UPPER & LOWER CAMPFIELD

Liverpool Road, Manchester | Manchester City Council

Design and Access Statement (Addendum)
March 2025

September 2023: Upper Campfield proposed Ground floor plan.

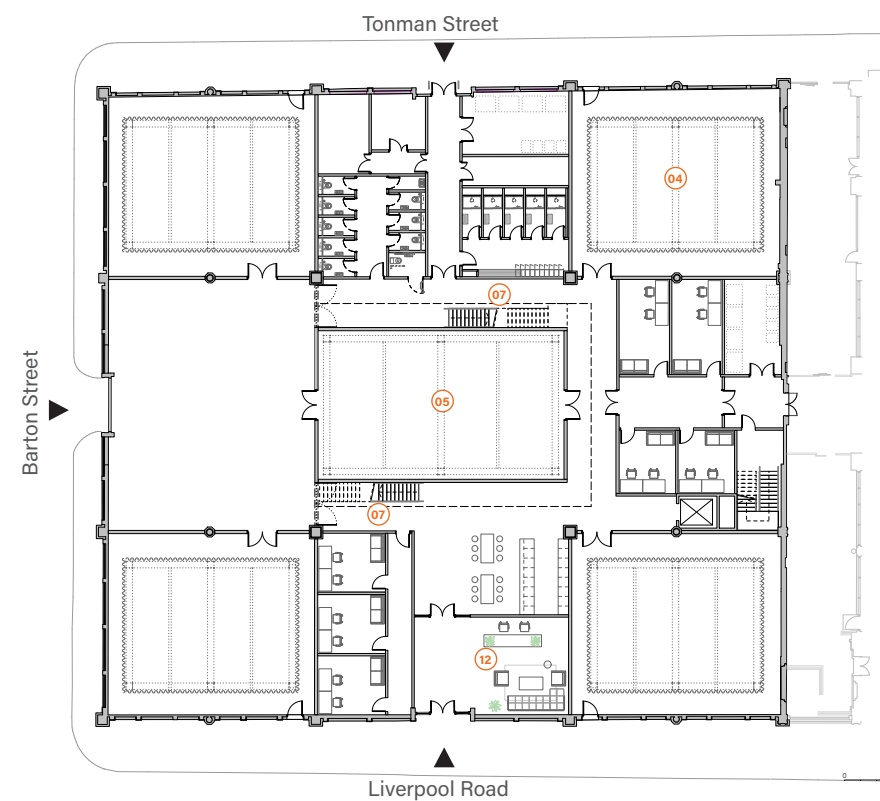
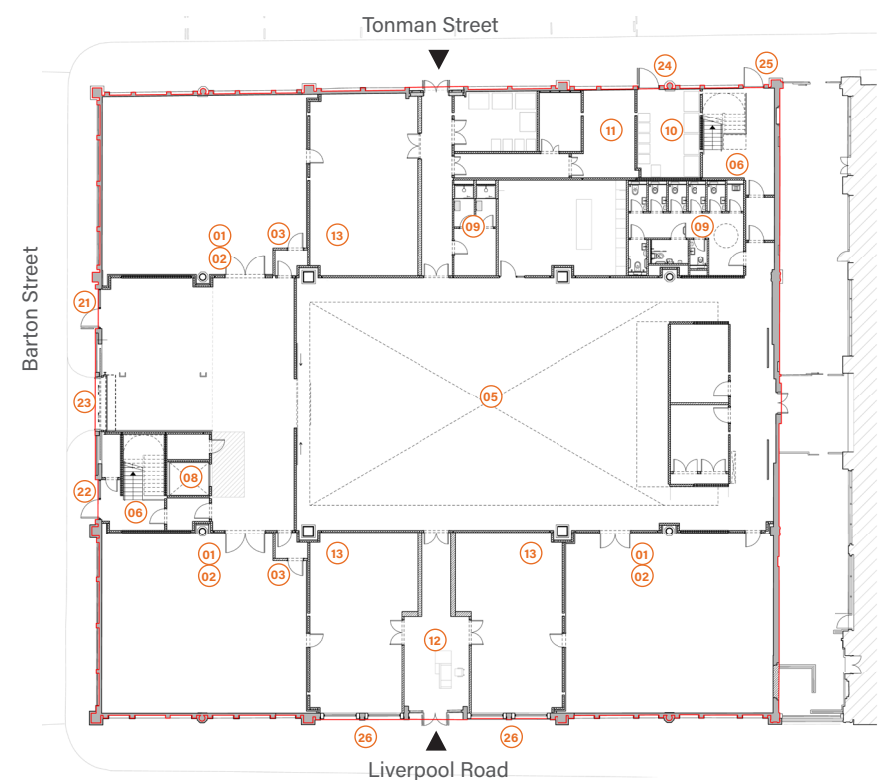
- 01 Larger Double doors to the corner studios: All double doors increased in size to all for props and equipment access to studios.
- 02 New doors to the corner studios: Double doors added-operational request.

- 03 Pockets added to all the studios: Airlocks added to studios for operational purposes.
- 04 Omitted 1No. corner studio: End user request.
- 05 Omitted central Studio 01: To allow for a greater appreciation of the central space.

- 06 Relocation of the staircases: To facilitate occupant discharge to the street and not internally in the event of a fire.
- 07 Omitted the staircases both sides of Studio 01: As a result of internal rationalisation in the event of a fire.

- 08 Relocation of the lift: Lift resized following operation review.
- 09 Relocation of the WCs/Showers: Following operational and fire review.
- 10 Relocation of the restaurant bin store: Following fire review.

- 11 Additional plant room: Larger studios required additional plant.
- 12 Relocation of the designated reception space: Following operational review.
- 13 Edit suites omitted for green rooms to studio spaces: Internal design revision, operational betterment.

September 2023: Upper Campfield proposed Mezzanine floor plan.

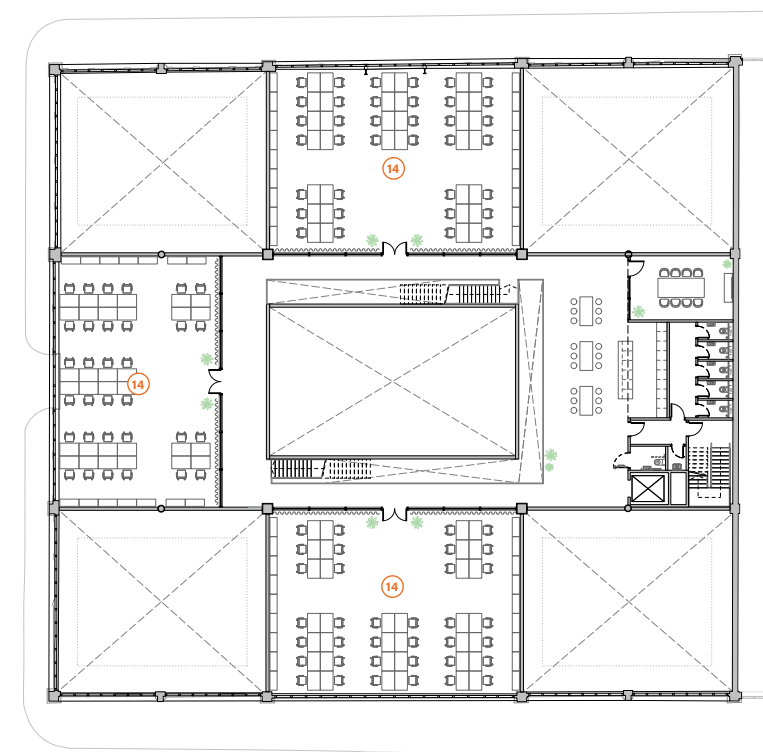
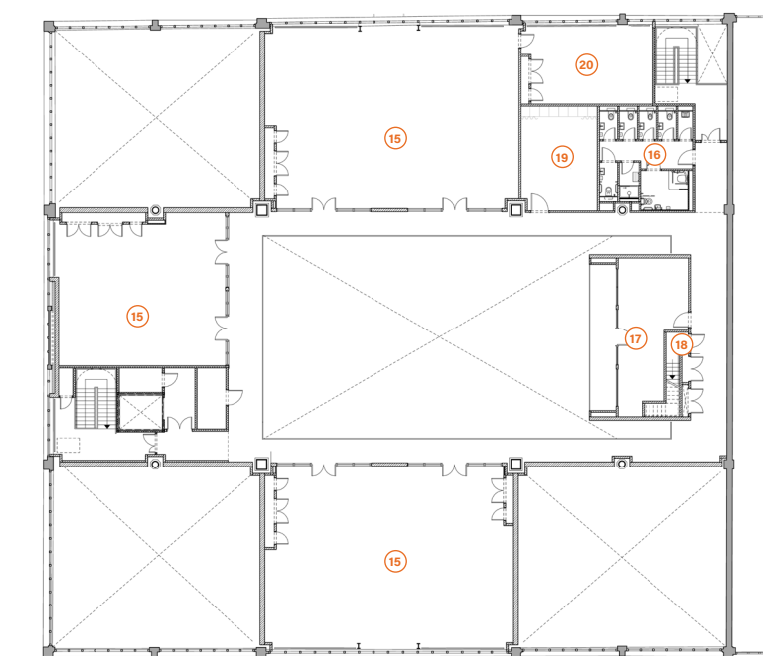
- 14 Removal of all workspaces: No longer required following client review.
- 15 3No. additional studio spaces: Loss of workspaces facilitated the additional smaller studio spaces, following client review.
- 16 Relocation of the WCs/Showers: Following operational review and redesign of studio spaces.
- 17 Additional viewing gallery: Internal design revision, operational betterment.
- 18 Additional plant deck: Larger studios required increase in plant.
- 19 Additional break out space: Client change.
- 20 Additional make-up room & green room: Internal design revision, operational betterment.

September 2023: Proposed long section through the Studio, Workspaces and Edit Suite area.

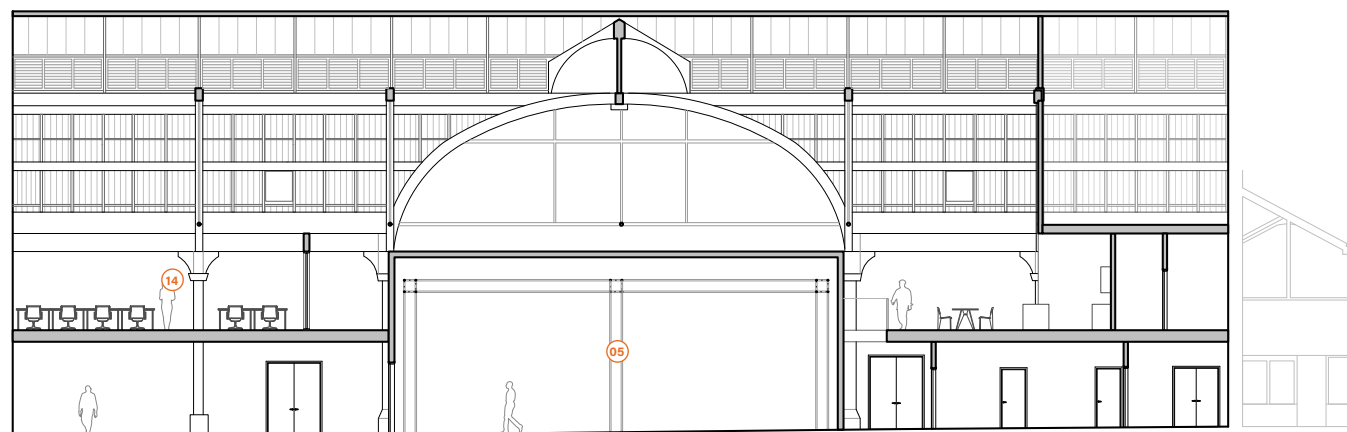
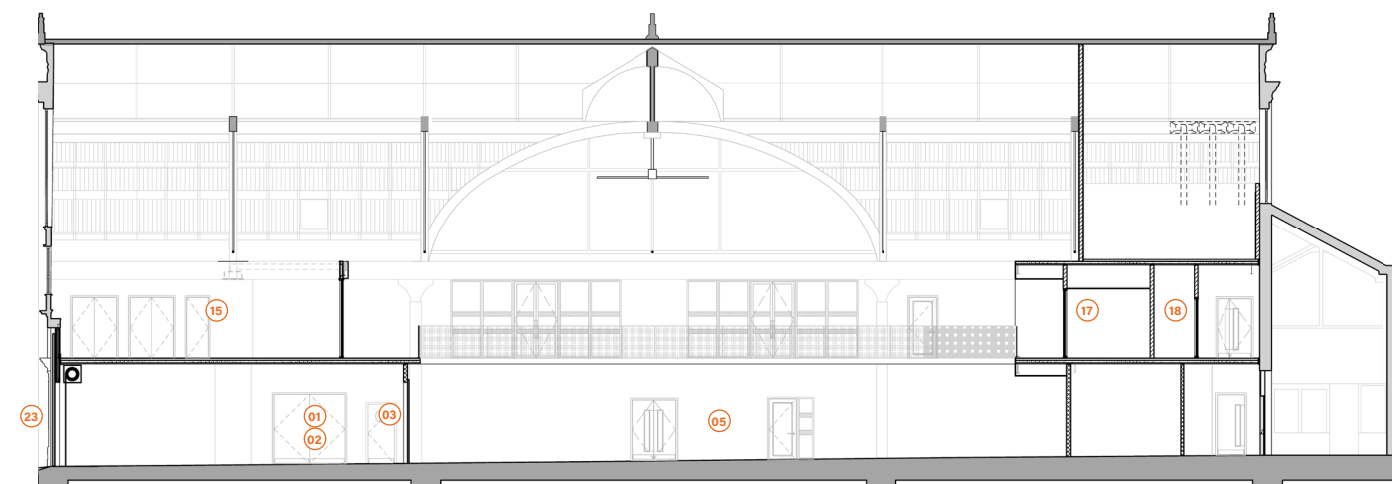
- 01 Larger Double doors to the corner studios: All double doors increased in size to all for props and equipment access to studios.
- 02 New doors to the corner studios: Double doors added-operational request.

- 03 Pockets added to all the studios: Airlocks added to studios for operational purposes.
- 04 Omitted 1No. corner studio: End user request.
- 05 Omitted central Studio 01: To allow for a greater appreciation of the central space.

- 06 Relocation of the staircases: To facilitate occupant discharge to the street and not internally in the event of a fire.
- 07 Omitted the staircases both sides of Studio 01: As a result of internal rationalisation in the event of a fire.

- 08 Relocation of the lift: Lift resized following operation review.
- 09 Relocation of the WCs/Showers: Following operational and fire review.
- 10 Relocation of the restaurant bin store: Following fire review.

- 11 Additional plant room: Larger studios required additional plant.
- 12 Relocation of the designated reception space: Following operational review.
- 13 Edit suites omitted for green rooms to studio spaces: Internal design revision, operational betterment.

- 14 Removal of all workspaces: No longer required following client review.
- 15 3No. additional studio spaces: Loss of workspaces facilitated the additional smaller studio spaces, following client review.
- 16 Relocation of the WCs/Showers: Following operational review and redesign of studio spaces.
- 17 Additional viewing gallery: Internal design revision, operational betterment.
- 18 Additional plant deck: Larger studios required increase in plant.
- 19 Additional break out space: Client change.
- 20 Additional make-up room & green room: Internal design revision, operational betterment.

September 2023: Proposed south elevation (Liverpool Road).

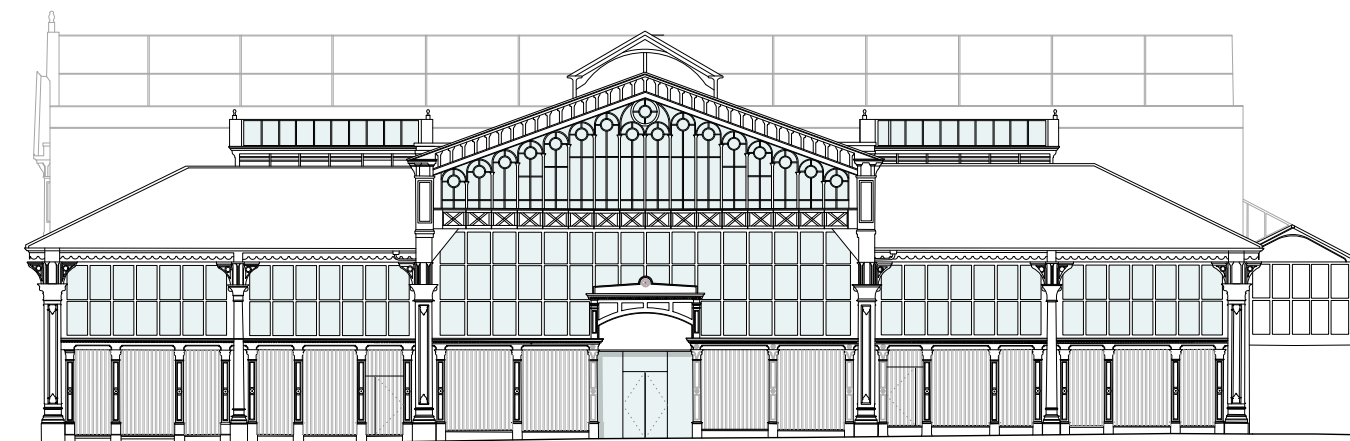
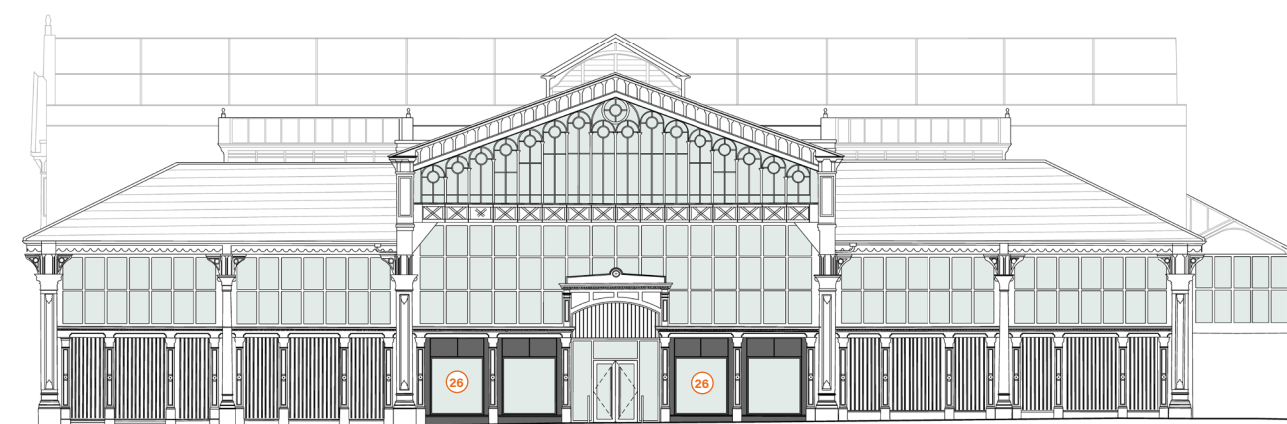
- 26 Elevational design proposal to have visual synergy with Lower Campfield windows, 2No. Full height glazed panels to replace the railing to both sides of the main entrance. Internal layout changes and green rooms require natural daylight.

September 2023: Proposed north elevation (Tonman Street).

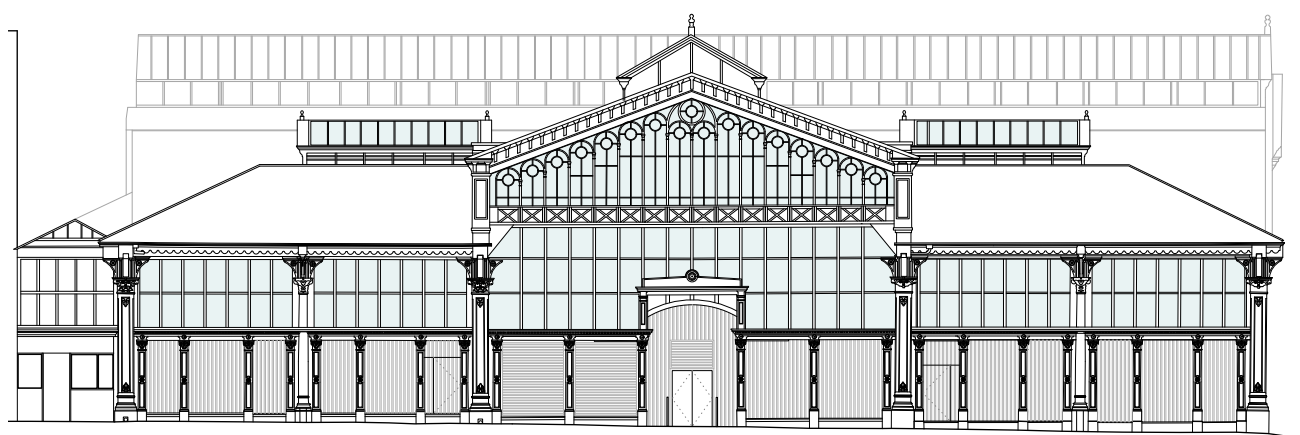
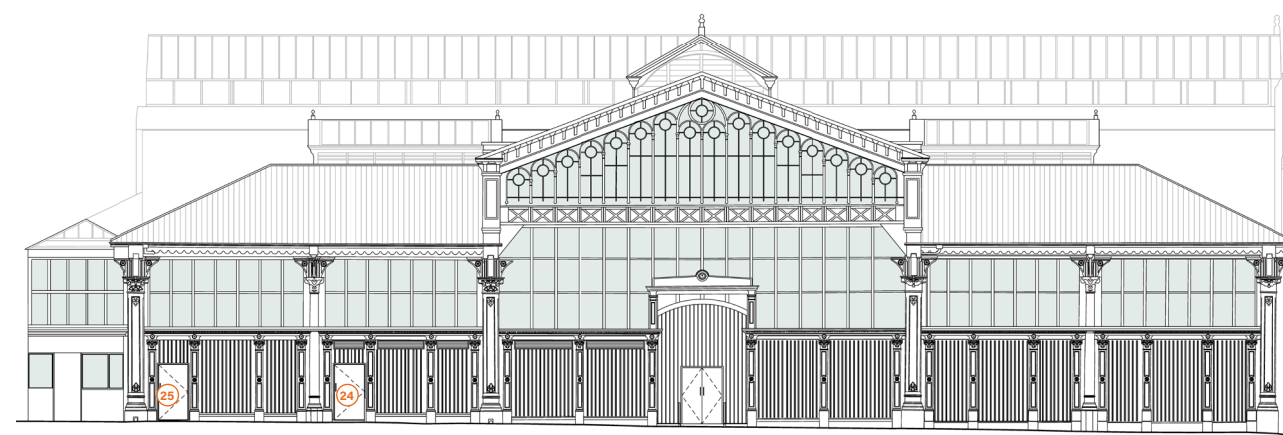
- 24 New double door and threshold to relocated bin store.
- 25 New fire escape door to base of staircase.

September 2023: Proposed west elevation (Barton Street).

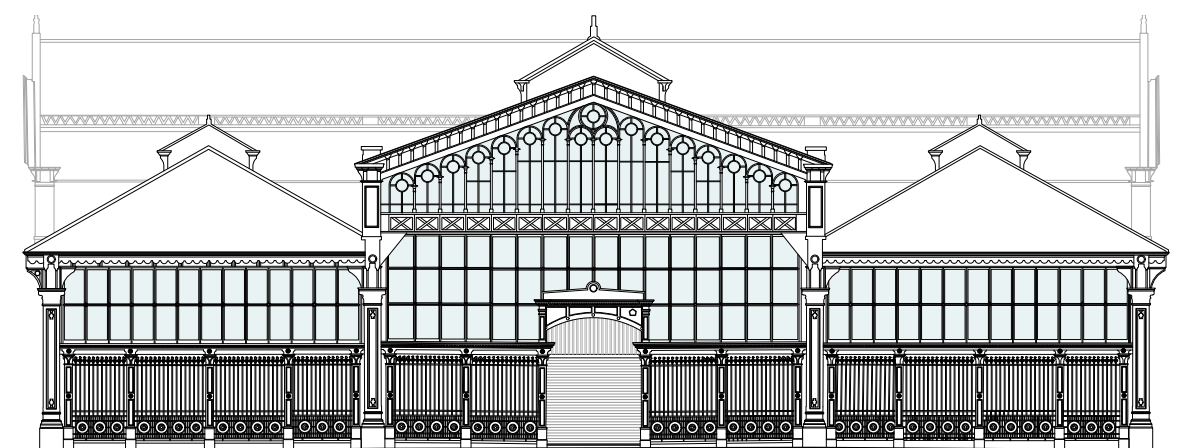
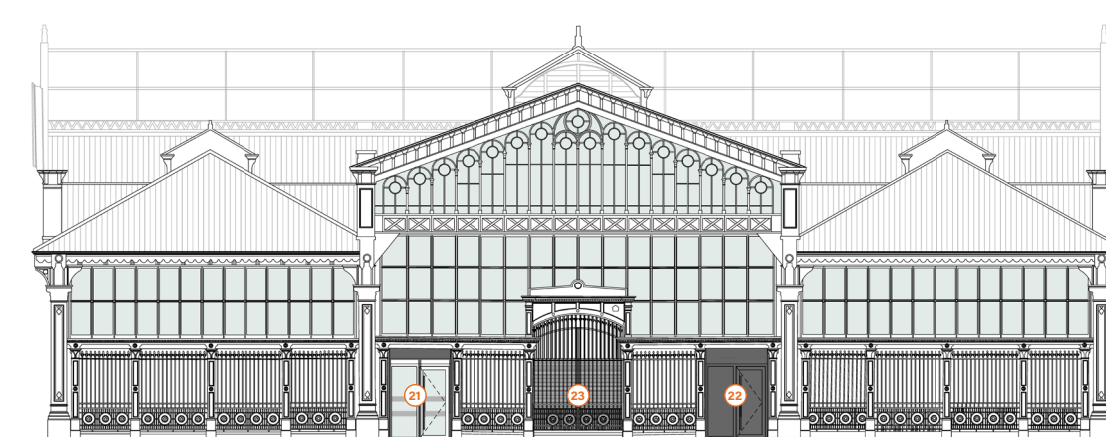
- 21 Additional pedestrian access door to internal reception area.
- 22 Fire escape door to base of staircase.
- 23 Existing iron gates to vehicular access made functional again, to be closed out of hours.
